**HIGHLAND CREEK
 MASTER PLAN AMENDMENT**

**CHARLOTTE - MECKLENBURG
 PLANNING COMMISSION
 INTER - OFFICE COMMUNICATION**

SUBJECT: Administrative Approval for Petition No. ~~006~~(c)
 Tax Parcel No. 029-231-01 (portion of)
 Revised Highland Creek R-9PUD Master Site Plan
 Ridge Road/Eastfield Road/Highland Creek Parkway

HIGHLAND CREEK - CHARLOTTE, NORTH CAROLINA

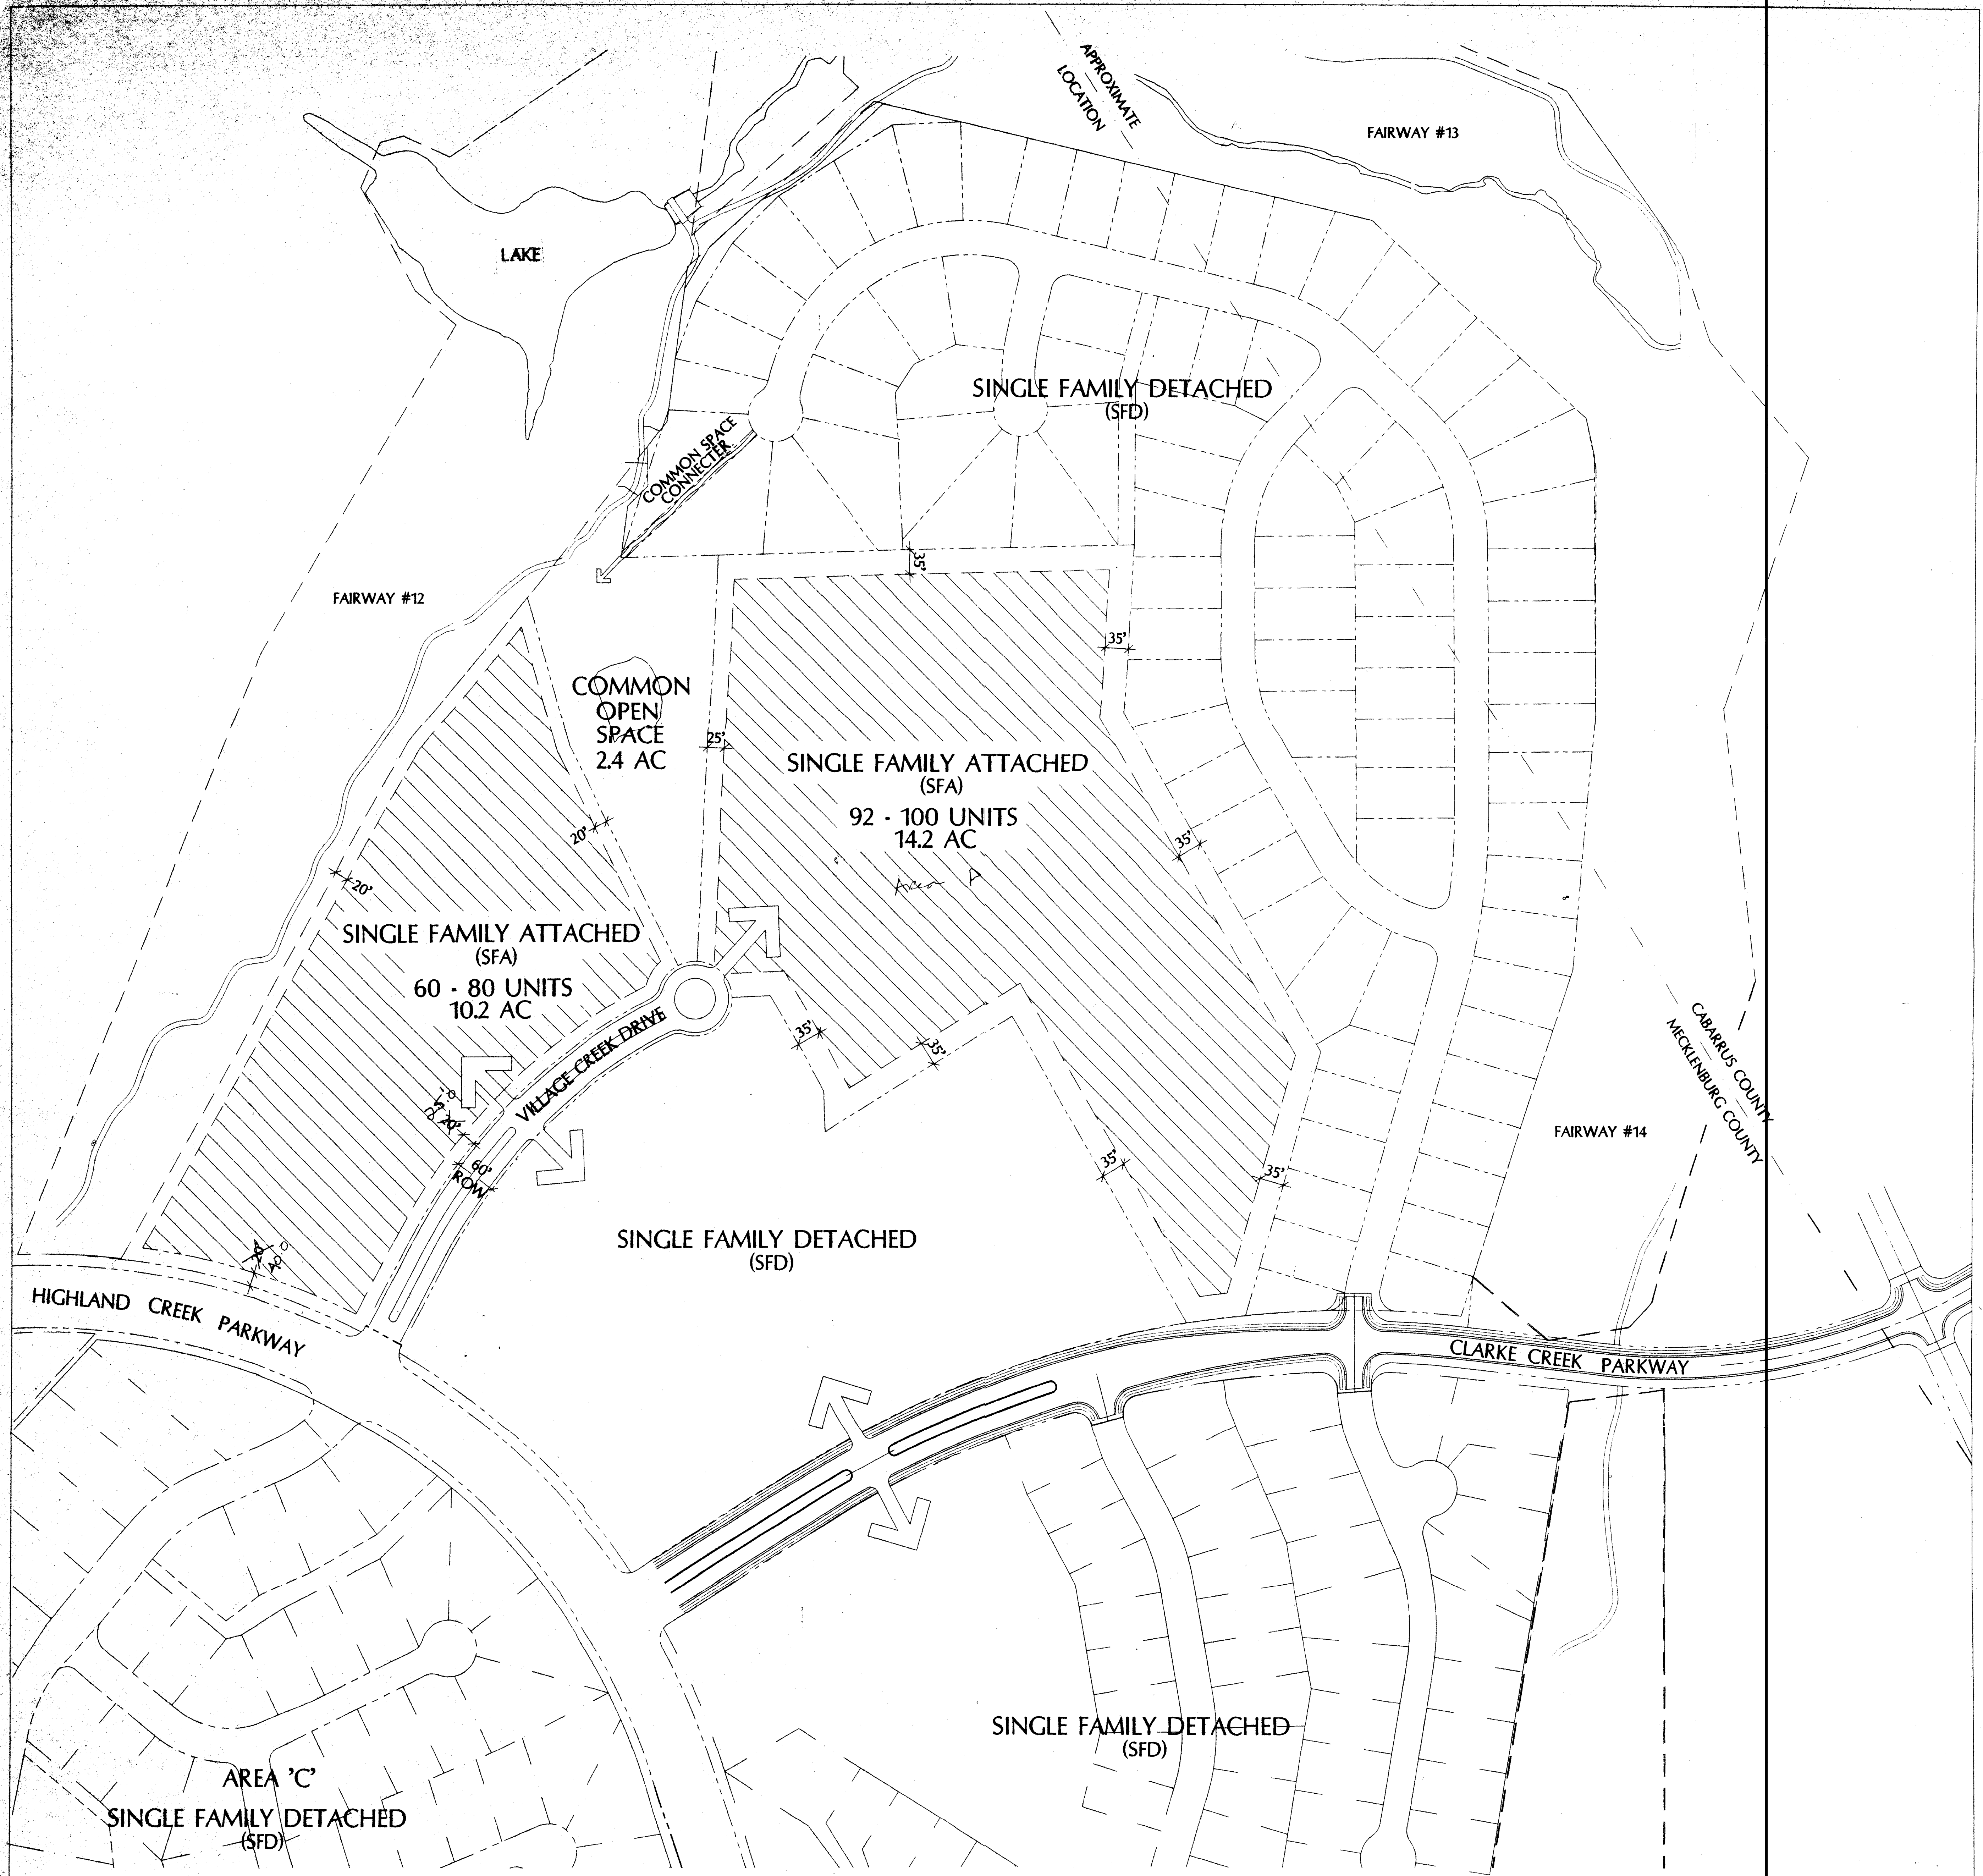
The shifting of some of the previously approved multi-family/single family attached (SFA) residential land use within the overall plan. There will be no increase in density or unit count with this action. It is simply a location change as illustrated by the accompanying plan.

A 30' buffer will be employed between the single family attached (SFA) parcel and the single family detached (SFD) parcels. Buffers will be comprised of natural vegetation and/or increased landscaping to provide a smooth transition between uses. Plant materials shall be massed and concentrated towards the property line. A 30' setback will be employed between the SFA parcel and Clarke Creek Parkway. A 25' setback remains between the SFA parcel and the common open space to the west.

Attached please find a copy of the revised master site plan for the Highland Creek development. The revised site plan reflects a reduction in width from 35 feet to 30 feet of a buffer between a 14.2 acre single family detached parcel and the single family attached parcel to the north and east. All required yards will remain as per the zoning ordinance so if it is a rear yard relationship than a 35 foot rear yard is required and if it is a side yard relationship than there will be a 20 foot side yard required. Please use this revised site plan when evaluating requests for building permits and certificates of occupancy.

MASTER PLAN AMENDMENT

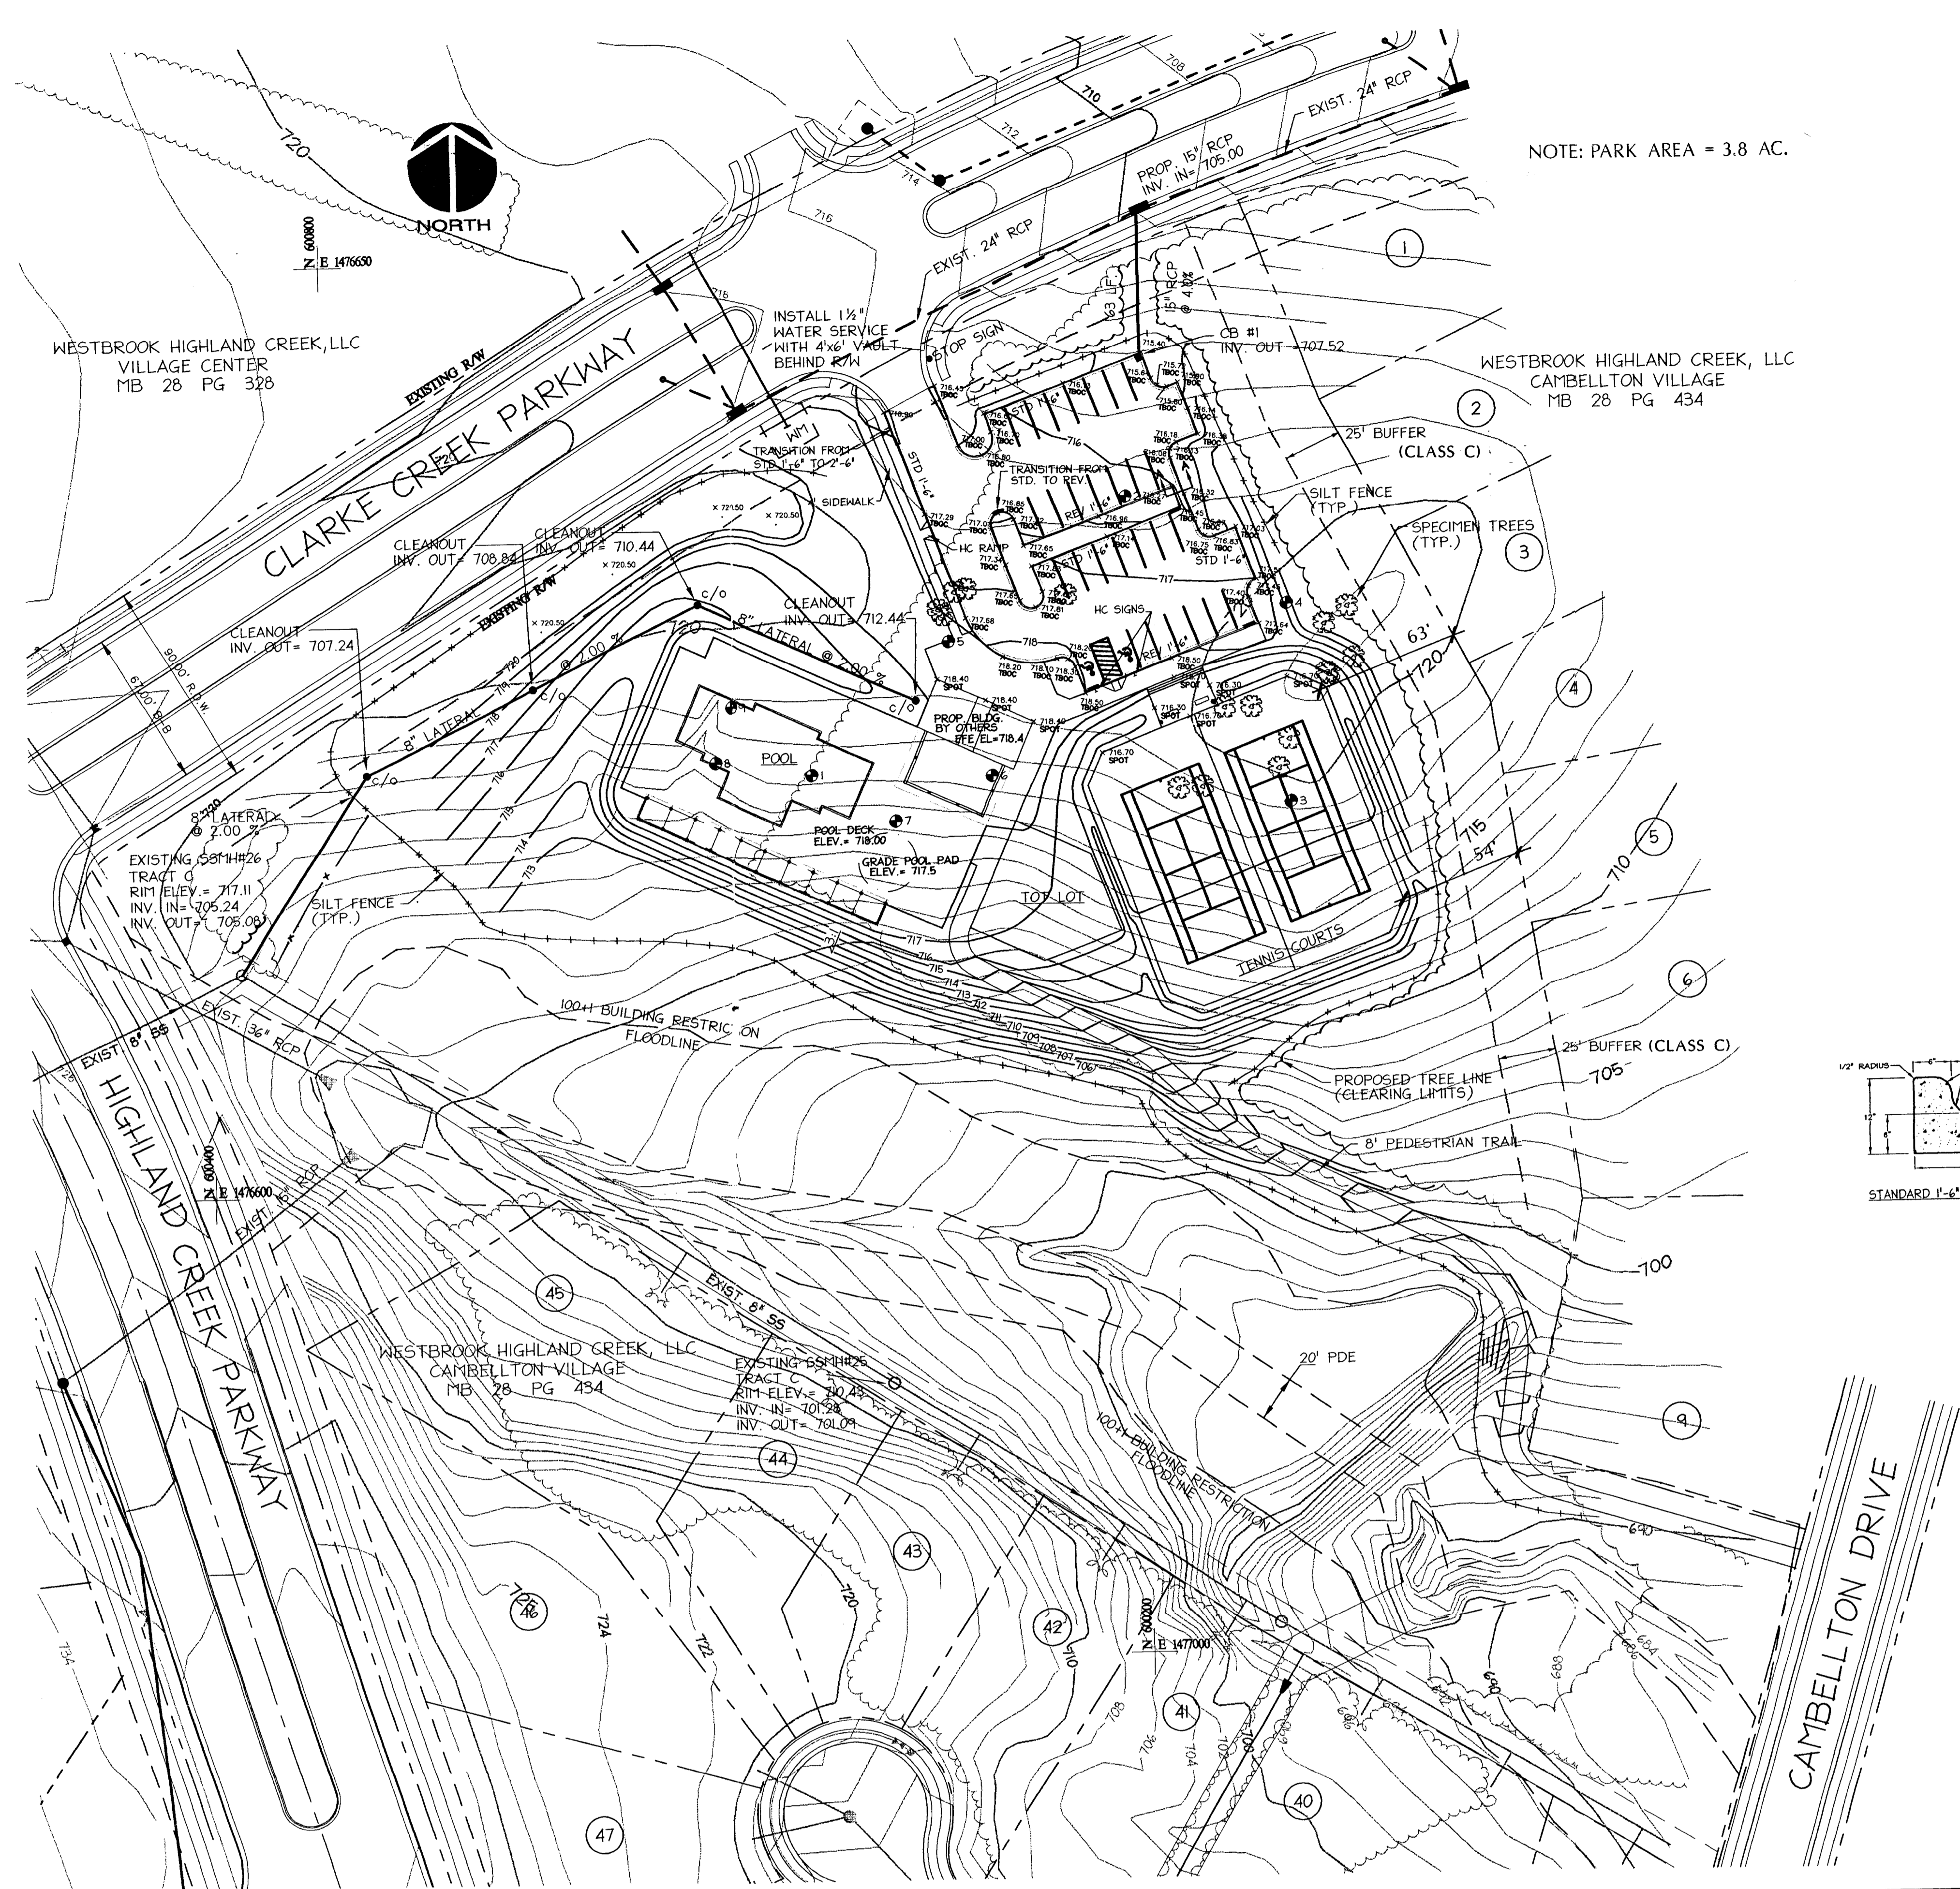
The shifting of some of the previously approved multi-family/single family attached (SFA) residential land use within the overall plan. There will be no increase in density or unit count with this action. It is simply a location change as illustrated by the accompanying plan.

A 35' setback / buffer will be employed between the single family attached parcel and the single family detached (SFD) parcel. Buffers will be comprised of natural vegetation and/or increased landscaping to provide a smooth transition between uses. Plant materials shall be massed and concentrated towards the property line.

Attached please find a copy of the revised master site plan for the Highland Creek development. The plan shifts single family detached lots from Area D to Area E and shifts single family attached units from Area E to Area D. The total number of approved single family attached and detached units remains the same. Please use this approved plan when evaluating requests for building permits and certificates of occupancy.

LAND USE PLAN

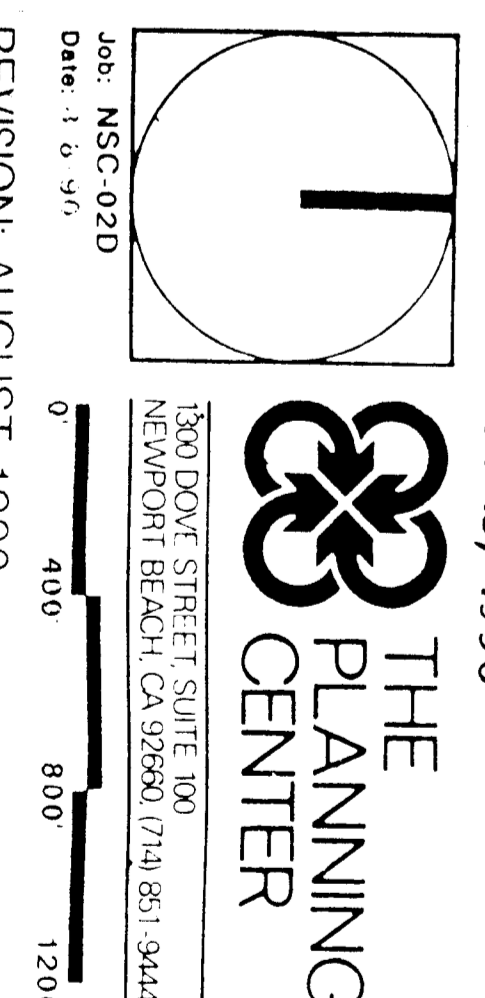
Attached is a copy of the revised plan showing the proposed reduction of single family detached and single family attached parcels. Area E indicates the new single family detached parcel and area D represents the new overall density of the development. Since this revised plan is in compliance with the overall development concept and does not increase the density of this site, I am administratively approving the revised plan. Please use the revised plan when submitting requests for building permits and certificates of occupancy.
